NORTHEAST UTILITIES

Millstone Nuclear Power Station, Unit No. 3
Transmittal of Responses to Questions 492.8 through 492.12

RESPONSE TO NRC QUESTIONS ON THREE-LOOP OPERATION

Figure ① 442-11-1

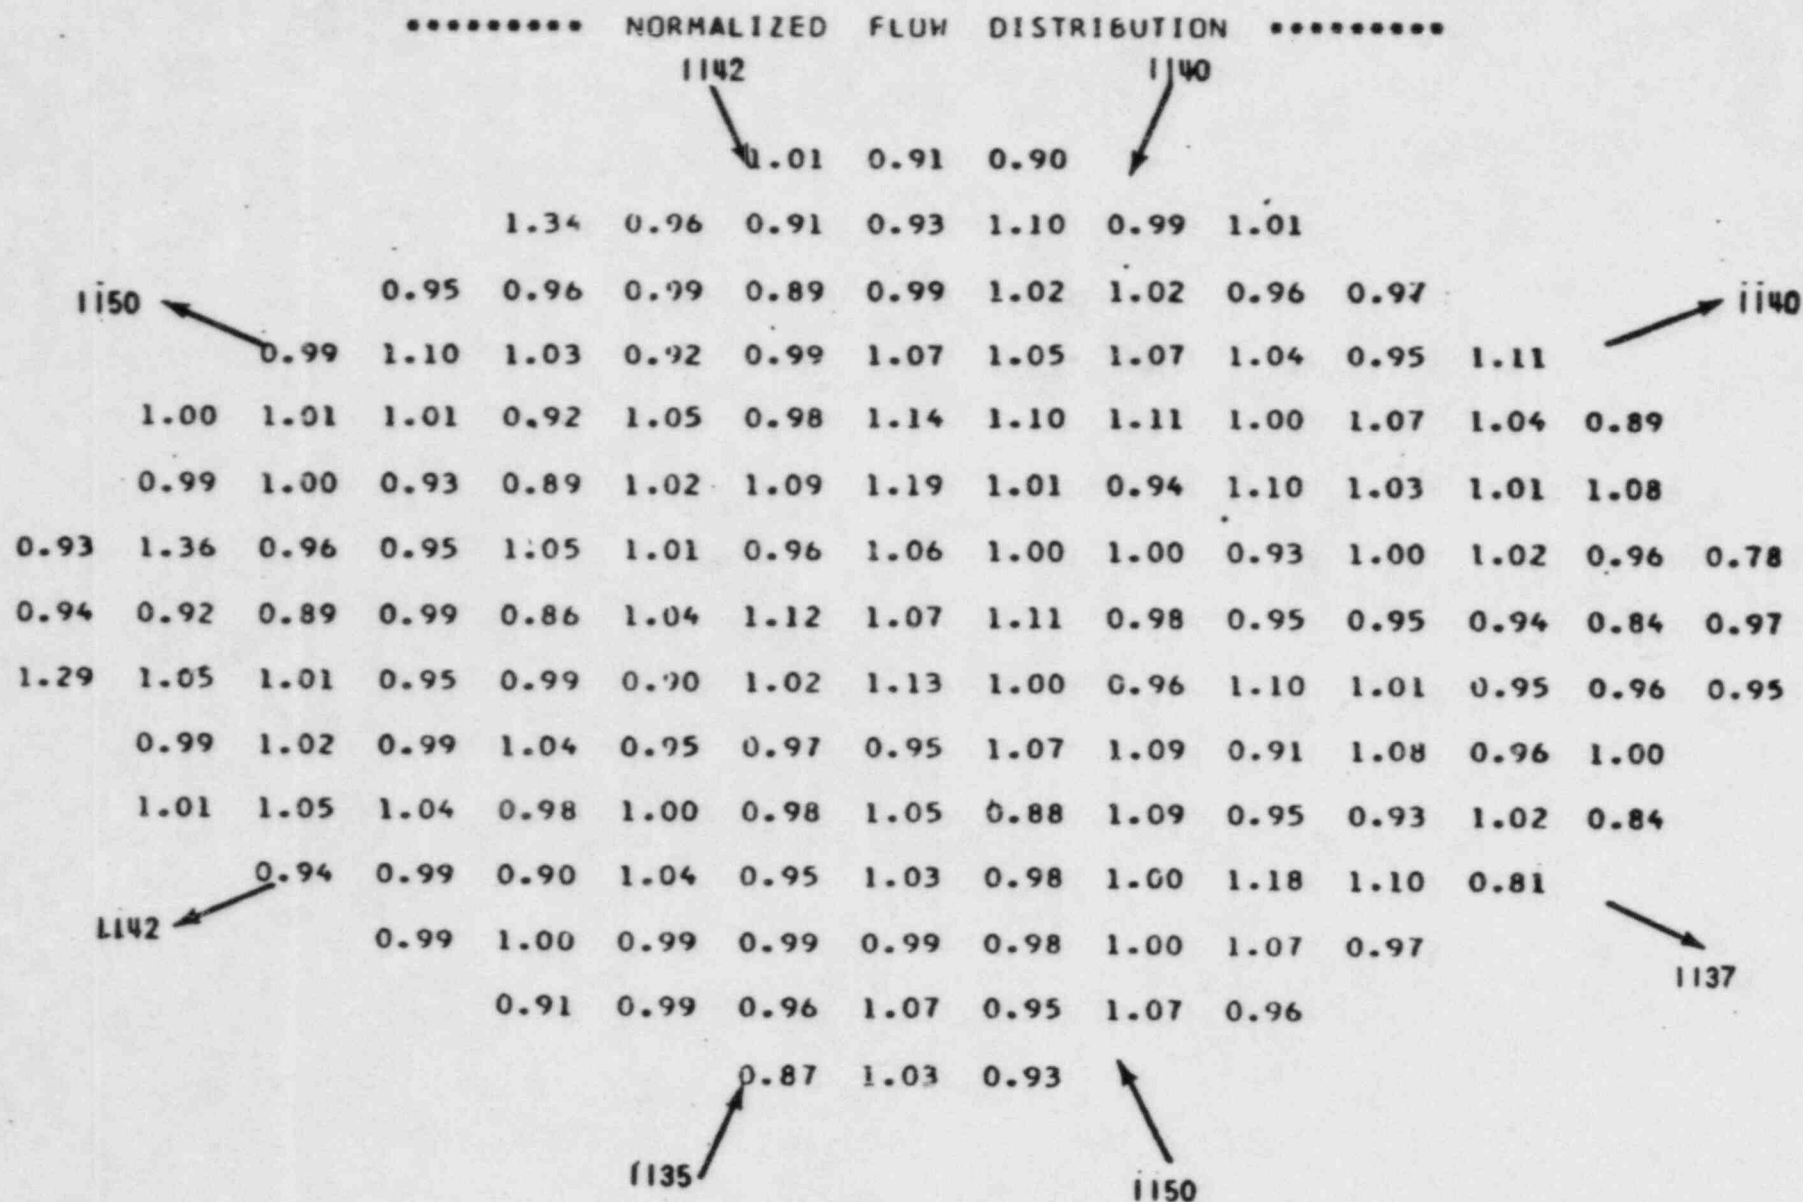
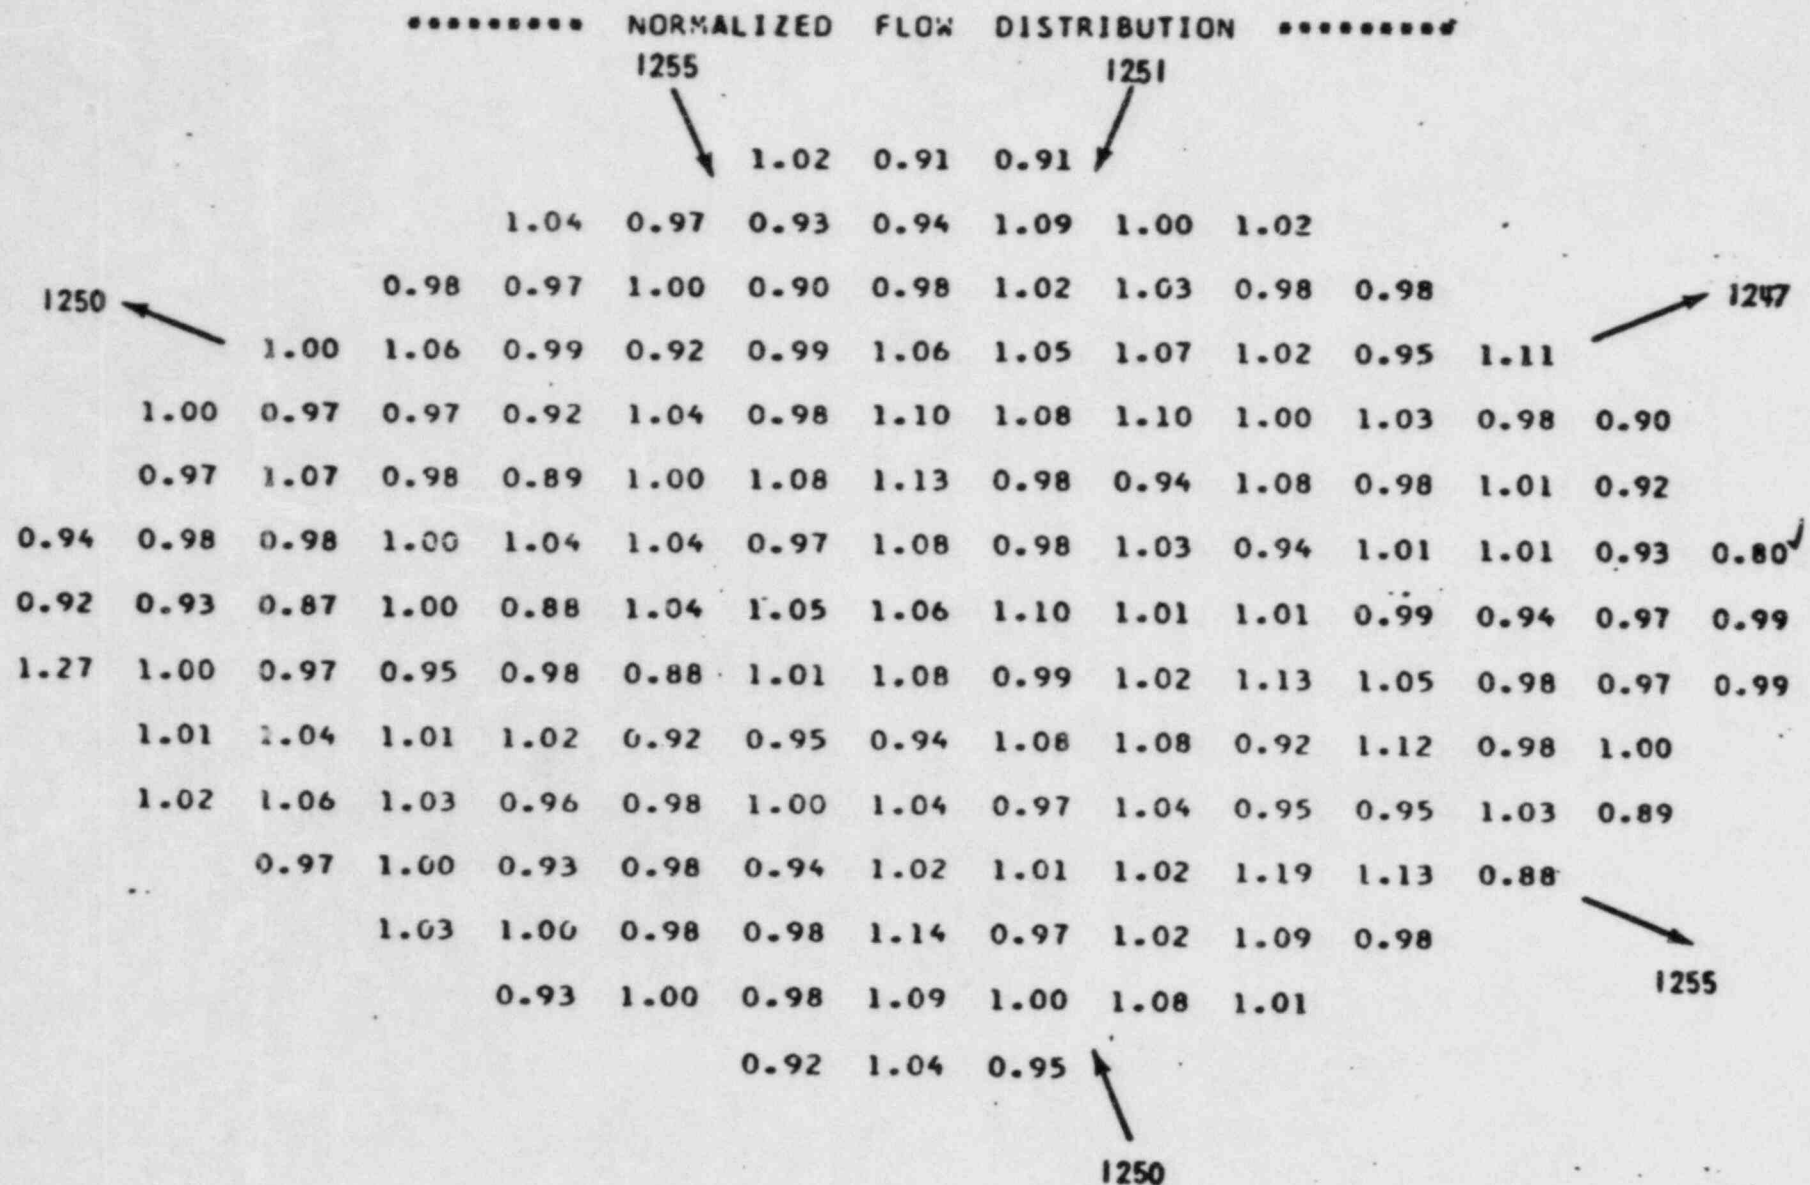
Inlet flow maldistribution is a possibility with three-loop operation. Have flow model tests or analytical studies been made for this effect? If so, provide the reference and results and also provide the following information.

1. What asymmetries exist (if any) in the core flow due to isolation of one loop? Provide inlet flow distribution maps for three- and four-loop operation and show the location of the active and inactive loop inlet positions relative to the flow distribution maps.
2. What is the effect of any inlet flow distribution on the hot channel DNBR?
3. What impact do any asymmetries have on power distribution, DNB limits and fuel integrity?
4. Provide information on flow instability with three-loop operation.

The core inlet flow distribution criteria used in the THINC analysis (DNBR evaluation) are based on 1/7 scale hydraulic reactor model tests (References 1 and 2). THINC analyses using this data have indicated that a conservative design basis is to consider a five percent (5%) reduction in the flow of the hot assembly. Studies made with the improved THINC model (Reference 3) show that it is appropriate to use the 5% reduction in inlet flow to the hot assembly for one loop out of service based on the experimental data in Reference 1 and 2.

The inlet flow distributions (from Reference 2) for three and four loops in operation have been provided for comparison (Figures 492.11-1 and 492.11-2).

Any asymmetries that exist due to three-loop operation have little or no impact on power distribution, DNB limits and fuel integrity. Even with extreme inlet flow maldistributions, hot channel enthalpy rise and DNBR are only slightly affected (Reference 3). Generic radial power distributions and a 5% flow reduction into the hot assembly used in safety analyses account for any inlet flow maldistributions. All restrictions that are placed on the fuel to ensure fuel integrity are applicable to both four- and three-loop operation. The various criteria that must be met are explained in the FSAR.
